STAFF RECOMMENDATION

1602 Shelby Avenue

Application: New Construction - Addition

Description of Project: Application for the construction of a rear addition that will be closer than twenty feet (20') to an existing garage.

Figure 2. Left side elevation inclusive of addition.

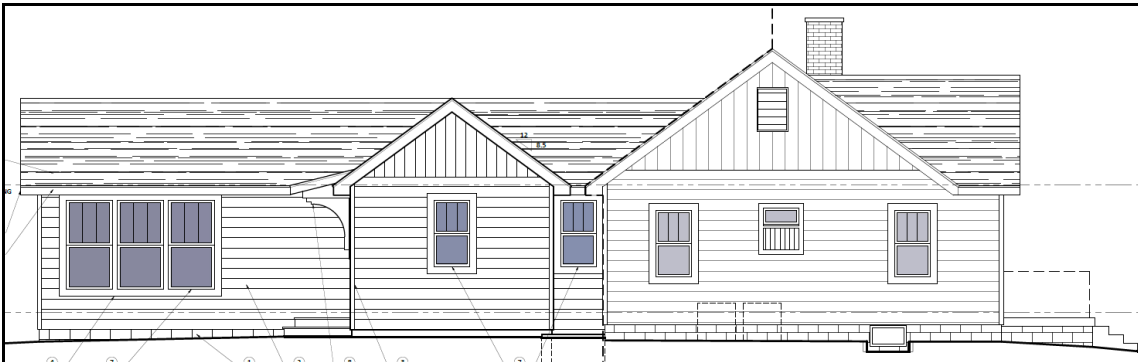
Mass, Scale & Connection: The proposed addition is situated at the rear of the house in such a way that it will not disturb either the front or the side facades. The addition could be removed in the future and the original historic form of the house would be intact.

The addition is about fifteen feet, six inches (15'6") tall, compared to the historic house which is about nineteen feet (19'), both measured from grade to the ridge. The foundation and eave heights will align with the historic house. The addition is about twenty-one feet, six inches (21'6") wide at the widest point and sits fully behind the house, which is about thirty-five feet (35') wide. The existing house is about forty-one feet (41') deep and the addition will add around thirty feet (30') of additional depth.

The roof slopes match the historic pitch at 8.5/12.

The existing house has a footprint of about eight-hundred-sixty square feet (860 sq ft) and the addition will increase the total square footage by just over five-hundred square feet (500 sq ft). The addition is not larger than the historic building.

The project meets section VI.B for mass, scale and connection.

Figure 3. Site plan.

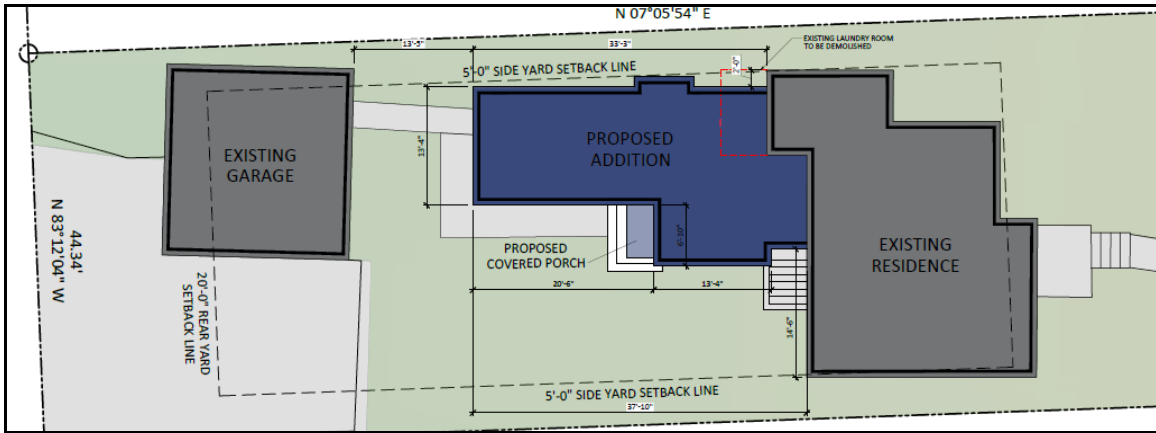
Siting and Setback: The addition will be five feet (5') from the right-side property line and a minimum of thirteen feet (13') from the left side property line. It will be more than fifty feet (50') from the rear property line. These conditions all meet base zoning.

There is an existing garage in the rear yard. The garage sits about fourteen feet, six inches (14'6") from the rear property line and about forty-two feet (42') from the rear of the existing house. The proposed addition will be thirteen feet, five inches (13'5") from the garage. The guidelines state that there should be twenty feet (20') between structures. Staff finds that the reduced distance could be appropriate in this situation because the addition is modest, the garage is existing and there will still be over thirteen feet (13') of separation. Further, the existing garage is sited nearly ten feet (10') further from the rear property line than required, which lessens the possible separation.

The location of utilities was not indicated. Generally, HVAC units and utility connections should be placed no closer to the street than the mid-point of the structure.

With the condition that the utility locations are approved by staff, the project meets Section VI.C. for siting and setback.
